Response to the Anonymous Referee #2's Interactive comment on **“Relative Timing of Uplift along the Zagros Mountain Front Flexure Constrained by Geomorphic Indices and Landscape Modelling, Kurdistan Region of Iraq”**

by Zebari et al. The responses are given in “Italic” font style.

Comments to the manuscript entitled “Relative Timing of Uplift along the Zagros Mountain Front Flexure Constrained by Geomorphic Indices and Landscape Modelling, Kurdistan Region of Iraq” by Zebari et al. (doi:10.5194/se-2018-124).

a) HI calculated from the SRTM (30m) 100 * 100 cell (3*3 km) moving window and resampled to 500 m cells; b) Getis-Ord statistic estimation with 1.5 km distance for the HI that was calculated from the SRTM (30m) and with a 500 m grid following the method described by Pérez-Peña et al. (2009).

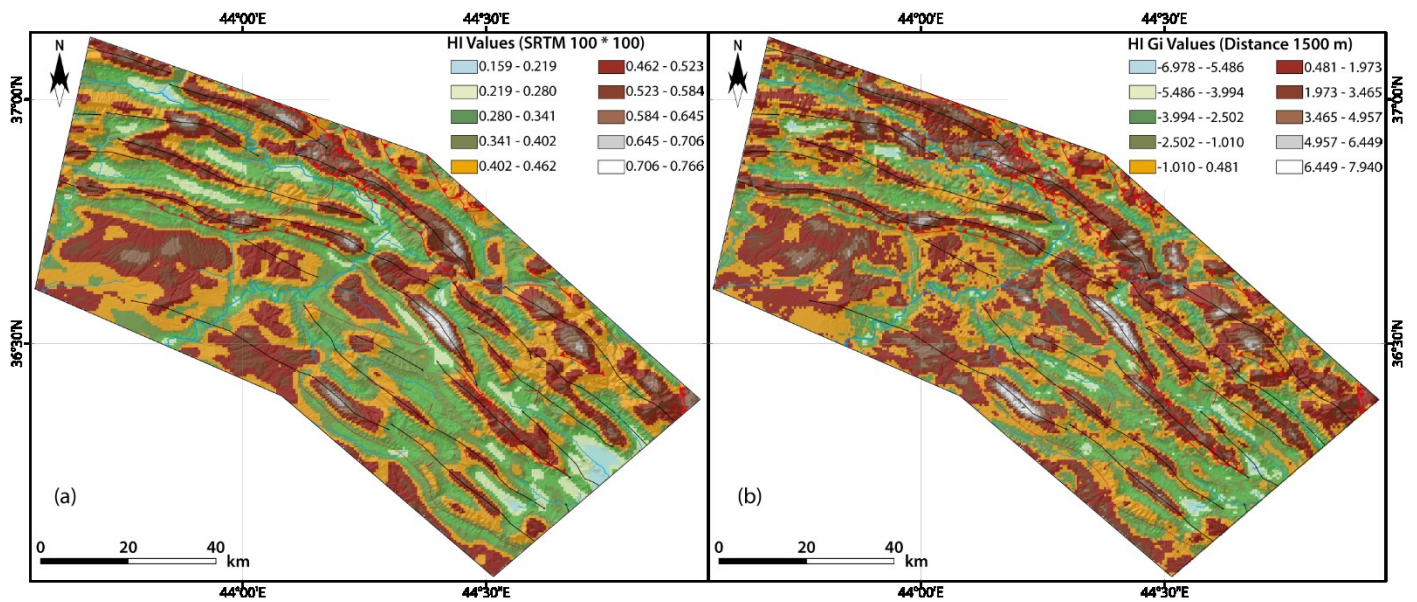
1) Considering the deformation style of the Folded Zone of the Zagros Mts. chain, the assumption of constant rock uplift seems too simplistic. Doesn't the evidence of NW-ward propagation of the Harir Anticline (used by the authors for supporting the scenario of independent and diachronist uplift in different fold segments) affect the assumption of homogeneous and constant uplift rate in each structure? In this frame, the hypsometric analysis performed for the entire anticlinal ridges seems to have no sense, while I would suggest using an approach to the hypsometric analysis such as the one proposed by Pérez-Peña et al. (2009).

Authors: We built our model to estimate the time it will take the present day Harir Anticline to reach the maturity level of the Akre Anticline under the assumption of constant climate and uplift rate. Then, we assume if the climate and uplift were the same in the past, the Akre Anticline has started to uplift before Harir Anticline in that estimated time. For this reason and for the sake of simplicity we used a constant uplift rate in the model.

We do not use absolute values of the geomorphic indices in our analysis, but we try to distinguish areas with relatively high values from those with relatively low values. Therefore, we think there is no need for applying the approach proposed by Pérez-Peña et al. (2009), because both the approach of Pérez-Peña et al. (2009) and our approach give similar results when it comes to defining areas with high and low (hypsometric integral, HI) values. Pérez-Peña et al. (2009) calculated HI for the given area with specific grid sizes (500m, 1km and 2km) and then calculated Moran's I index for each case to detect autocorrelation patterns in the data distributions. They conducted hot spot analyses by using the Getis-Ord G_i^ analysis within a specified distance (5km) to map the clusters of high and low HI values. In our approach, we calculated HI (and other indices) for each pixel by including the surrounding data of a specified distance based on the size of the used moving window. This means the results already have a relation with the surrounding cell without using Moran's I index and Getis-Ord G_i^* analysis. In the example given here (see the Figure below), first, we calculated HI from SRTM (30m resolution) by using a moving window of 3*3 km and resample it to a 500m grid, then we used the approach by Pérez-Peña et al. (2009) for the same SRTM data with a grid of 500m and conducted Moran's I index and Getis-Ord G_i^* analysis for the cluster using 1.5 km distance. The results are similar in aspect of defining clusters of high and low HI values. We added this information to the manuscript.*

Precipitation anomalies for Lake Van, Turkey, for the last 300 ka (data were obtained from Mona Stockhecke by personal communication; Stockhecke et al., 2016).

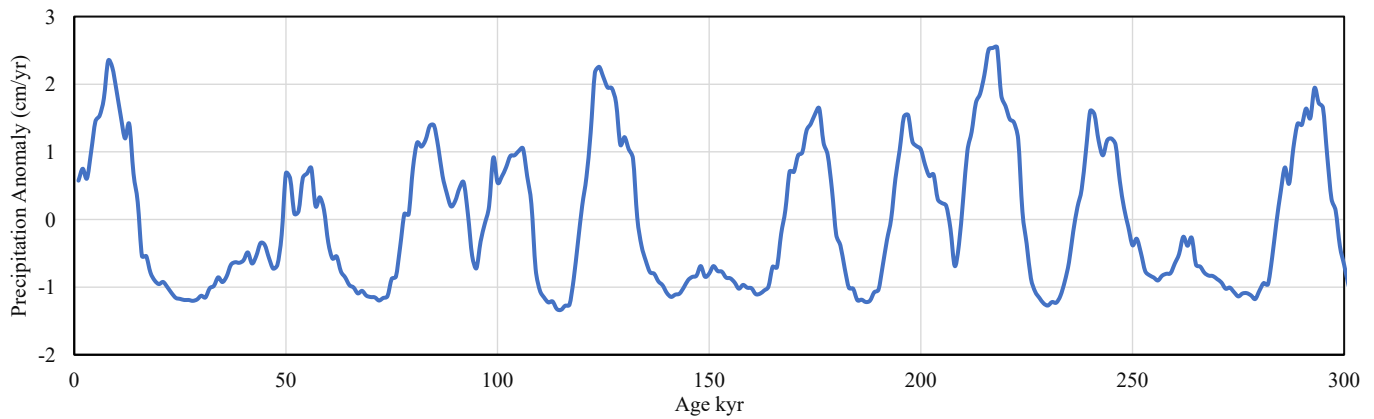
2) Also the use of the only equations for fluvial erosion and diffusion processes for landscape evolution modelling may be too simplistic. Besides the justifications provided by the authors in section 5.2, it sounds not realistic that sedimentation on the slopes of anticlines can be neglected over the time-span of landscape evolution modelling (105 years), as well as the assumption of constant erosion rates (and climate!).

Authors: The use of equations for fluvial erosion and diffusion processes only and neglecting the sedimentation in the model is explained in section 3.2. In such a landscape with steep slopes, the detachment-limited erosion due to the fluvial system tends to be the dominant process. Even if there is some fluvial sedimentation, it will be too small to affect the landscape. In addition, no notable sites of fluvial deposition were found on the anticline and its flanks from the field investigation and from satellite imagery. We add this information in the new version of the manuscript to clarify the reason for neglecting slope deposition (Section 3.3 Lines 5-9). In the model, the applied parameters were constant, while the erosion rate varies with the instant upstream drainage area and instant slope following the stream power incision law. The climate was kept constant for the sake of simplicity. The average of modeled paleo-precipitation anomalies for at least the last 300 kyr in the Eastern Mediterranean was close to zero as seen from the record of Lake Van in Turkey, some 200 km NNW of our study area (see the Figure below). Furthermore, considering the dimensions of the area, the changes in climate, if any, would have been constant over the entire study area, hence, affecting the three anticlines in the same way.

Black is the 1000-contour line from the input and red is the 1000-counter line from the output after 100 kyr.

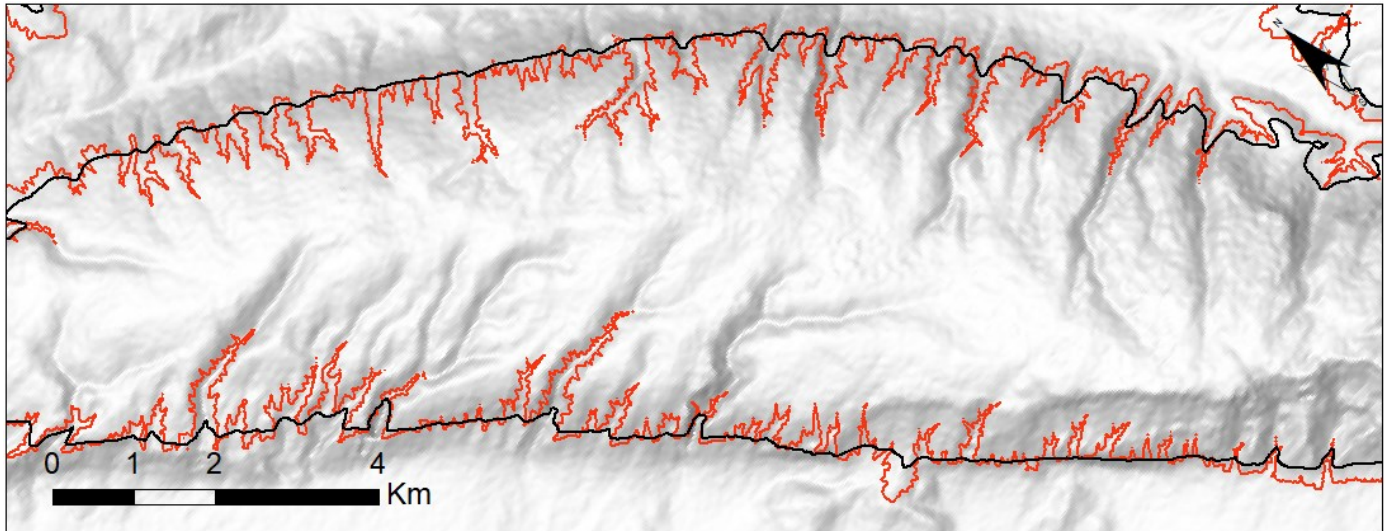
PAGE 11, LINES 13-14: authors state that “The evolving drainage system overprints the pre-existing one in the input and gradually becomes more deeply incised from the anticline flanks curving toward its core (Fig. 9)”. This is not evident in Fig. 9, according to what already explained in the general comment 3).

Authors: We think it is clear how the erosion is carving deeply toward the anticline core as it can be noticed from the contour map. Here, we show the 1000-contour line to show that (see the Figure below).
